FORM APPROVED
OMB NO. 1004-0135
Expires: July 31, 2010**SUNDRY NOTICES AND REPORTS ON WELLS**
*Do not use this form for proposals to drill or to re-enter an abandoned well. Use form 3160-3 (APD) for such proposals.***SUBMIT IN TRIPLICATE - Other instructions on reverse side.**

Yates Petroleum Corporation plans to plugback and recompleat this well as follows:

WELL NAME: Polo AOP Fed Com # 6 FIELD: Dagger Draw

**Polo AOP Federal Com 6
30-015-28871
Yates Petroleum Corporation
December 07, 2012
Conditions of Approval**

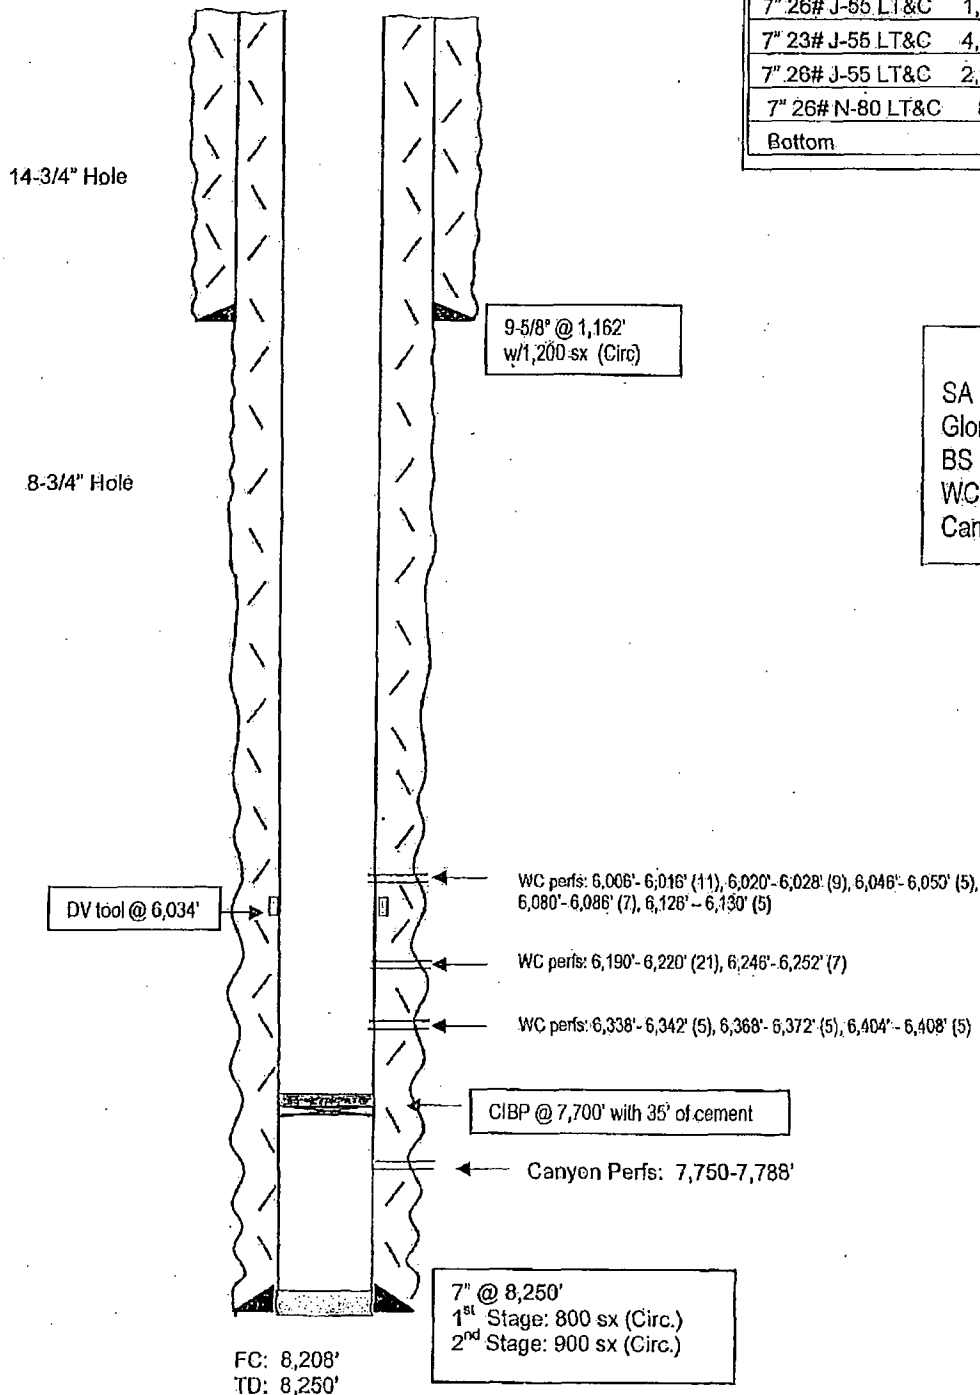
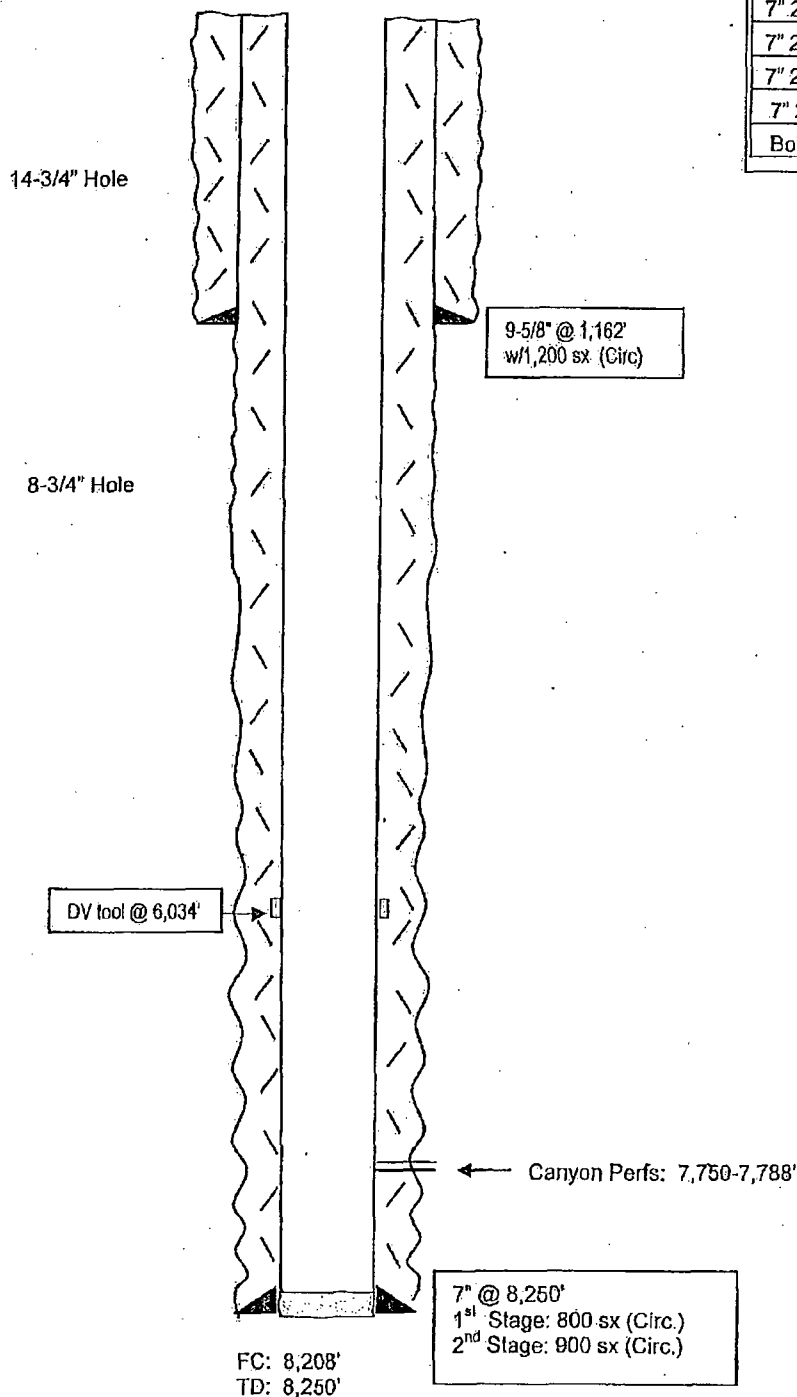
- 5. CIBP at 7,700' okay. Operator shall tag CIBP and place a 25 neat Class H cement plug on CIBP. No tag required.**
- 6. All waste (i.e. drilling fluids, trash, salts, chemicals, sewage, gray water, etc.) created as a result of work over operations shall be safely contained and disposed of properly at a waste disposal facility. No waste material or fluid shall be disposed of on the well location or surrounding area. Porto-johns and trash containers will be on-location during fracturing operations or any other crew-intensive operations.**
